SUBJECT: LICENSEE'S DRAFT CHANGES TO THEIR GRADED QUALITY ASSURANCE
OPERATIONS QUALITY ASSURANCE PLAN (OQAP) APPLICATION, SOUTH
TEXAS PROJECT, UNITS 1 AND 2 (TAC NOS. M92450 AND M92451)

SUBJECT: LICENSEE'S DRAFT CHANGES TO THEIR GRADED QUALITY ASSURANCE
OPERATIONS QUALITY ASSURANCE PLAN (OQAP) APPLICATION, SOUTH
TEXAS PROJECT, UNITS 1 AND 2 (TAC NOS. M92450 AND M92451)

OQAP CHANGE QA-032
SUMMARY OF CHANGES
Page 1 of 3

GQA PROCESS

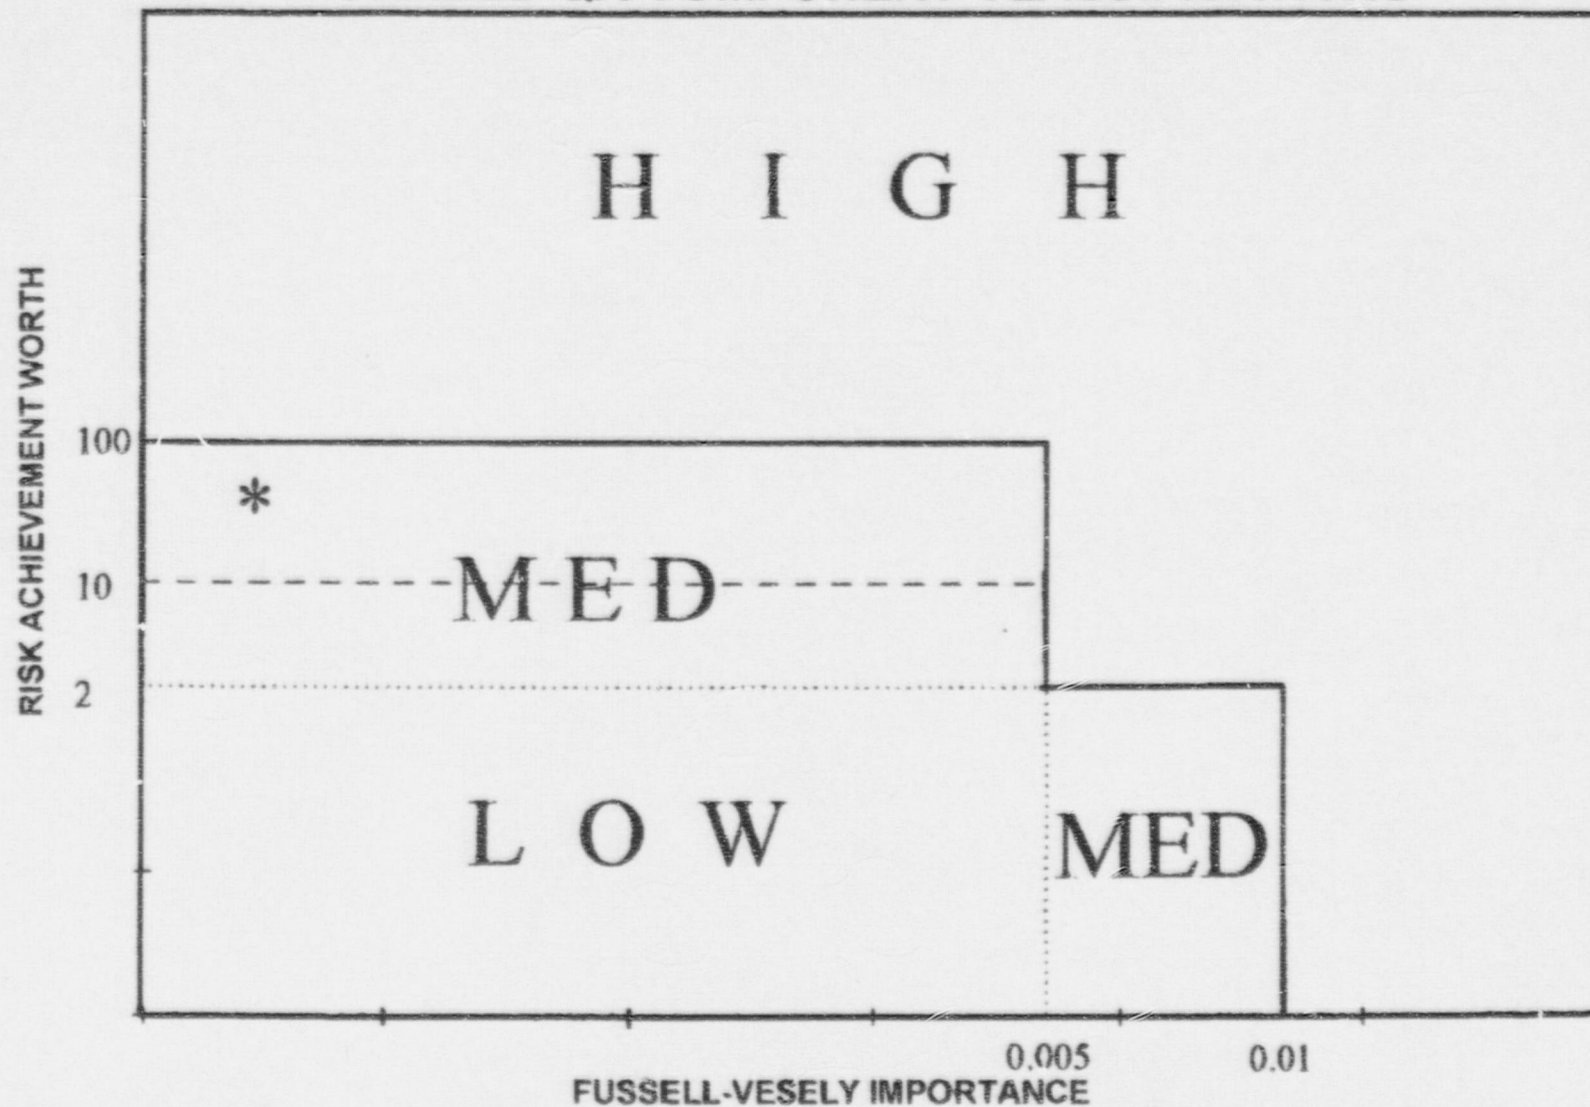
See attached revised flow chart titled GQA Process and figure titled, Probabilistic Risk Importance Thresholds for Input for Graded QA Component Classifications.

* SR Components with a RAW between 10 and 100 are to have Full QA applied to the critical attributes associated with that RAW
